UNITED STATES
DEPARTMENT OF THE INTERIOR
BUREAU OF LAND MANAGEMENTFORM APPROVED
OMB No. 1004-0137
Expires: July 31, 2010**SUNDRY NOTICES AND REPORTS ON WELLS** *OCD Artesia*
Do not use this form for proposals to drill or to re-enter an abandoned well. Use Form 3160-3 (APD) for such proposals.5. Lease Serial No.
SHL NM-0531075 BHL NM-104965 ✓
6. If Indian, Allottee or Tribe Name**SUBMIT IN TRIPLICATE** - Other instructions on page 2.

☒ Oil Well ☐ Gas Well ☐ Other7. If Unit of CA/Agreement, Name and/or No.
NM-070951C2. Name of Operator
STRATA PRODUCTION COMPANY8. Well Name and No.
FORTY NINER RIDGE UNIT #14 ✓3a. Address
PO BOX 1030, ROSWELL, NM 88202-10303b. Phone No. (include area code)
575-622-1127

UPDATED CEMENTING PLAN - NO DV TOOL ON 7" CSG. 7" CEMENT TO SURFACE. 4 1/2" LINER CEMENT WITH 590' TIEBACK TO 7" CSG.

Forty Niner Ridge Unit #14
Strata Production Company
30-015-38563
July 7, 2011
Conditions of Approval

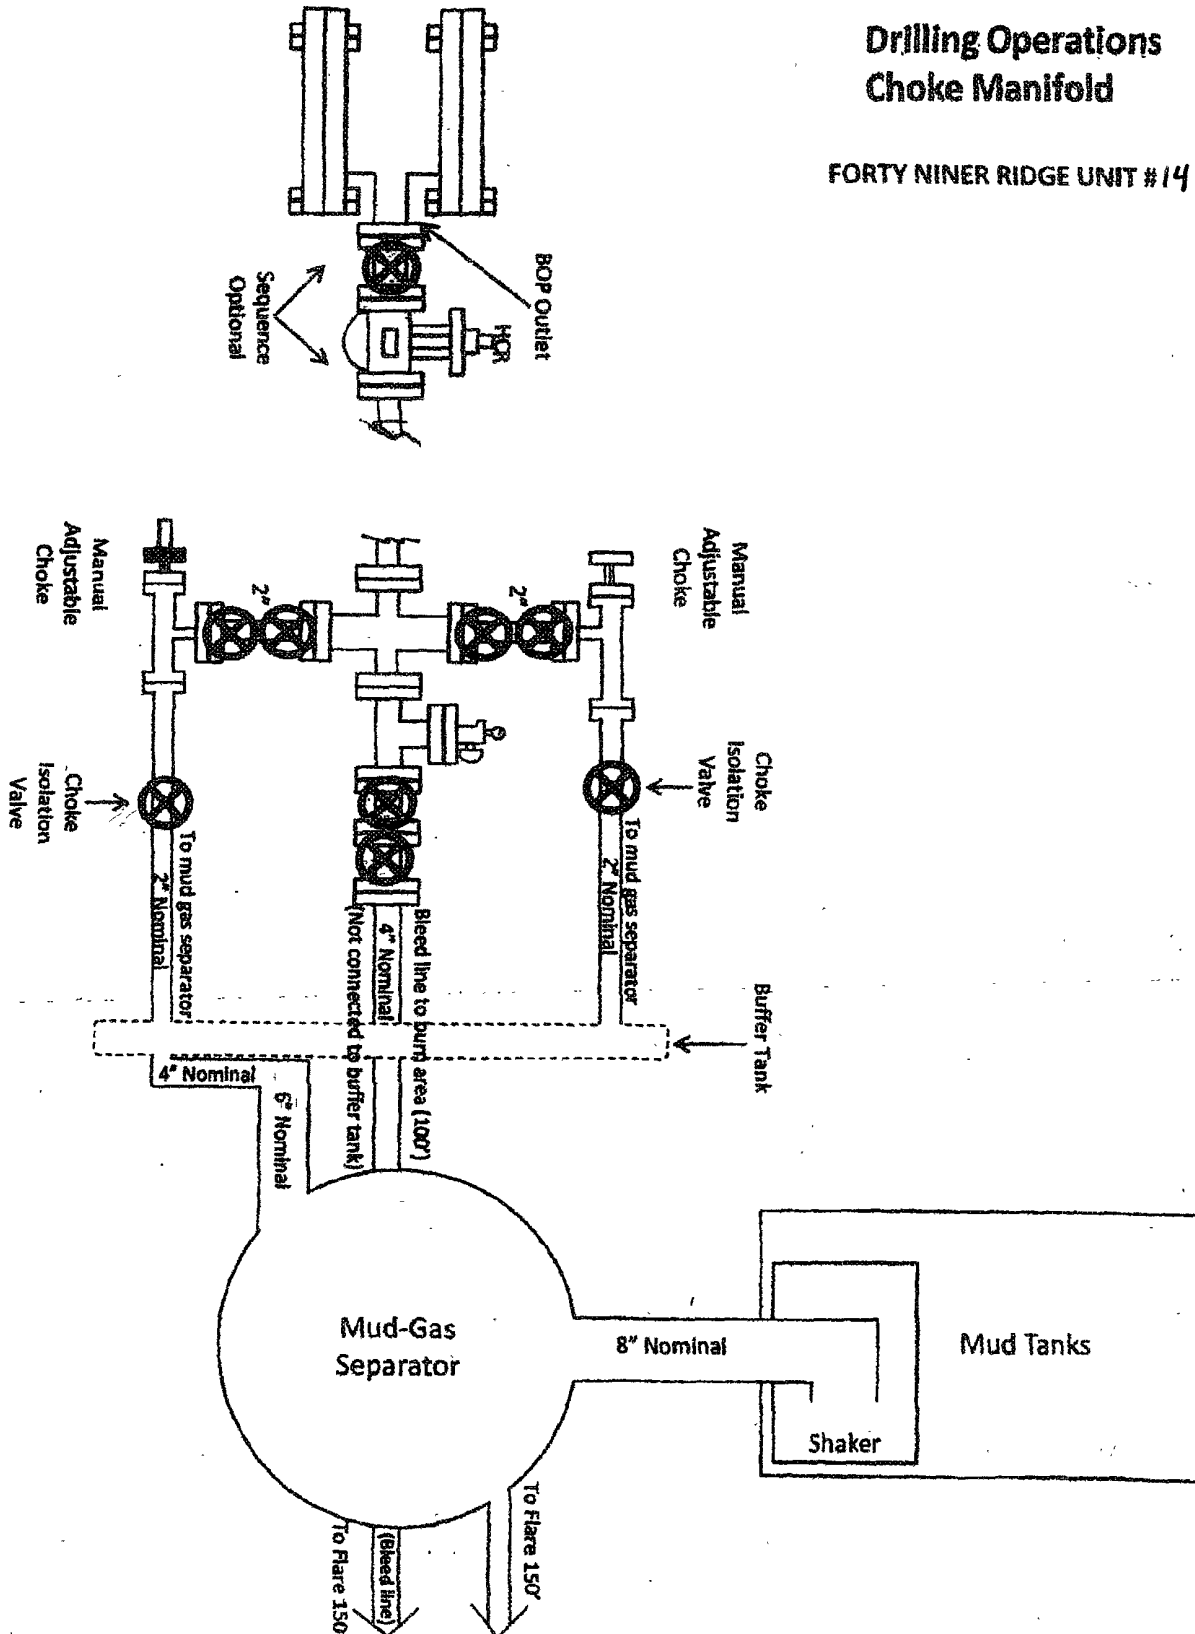
1. Operator is requesting to revise cementing procedures on the well by:
 - conducting a single stage cement job instead of a two stage cementing the 7" production casing
 - cementing the 4-1/2" production liner in the drainhole and delete use of the hydraulic set packers.

- a) While utilization of a single stage cement job on the 7" casing is possible, the use of two stage cementing procedure will increase the likelihood of successfully getting cement returns to surface. Hydrostatic pressure on the formation below 4500' will be reduced by approximately 800 psi ($3.5 \text{ ppg} \times .052 \times 4500'$) by use of the two stage cement job procedure. Therefore, a two stage cementing procedure is required.
- b) Cementing of the 4-1/2" liner in the drainhole as an alternative to the isolation packers system is approved.
- c) Centralizers suitable for horizontal sections shall be used on the 4-1/2" liner in the drainhole.
- d) The revised BOPE equipment specifications are approved.
- e) All other terms of the previous drilling Conditions of Approval will still apply.
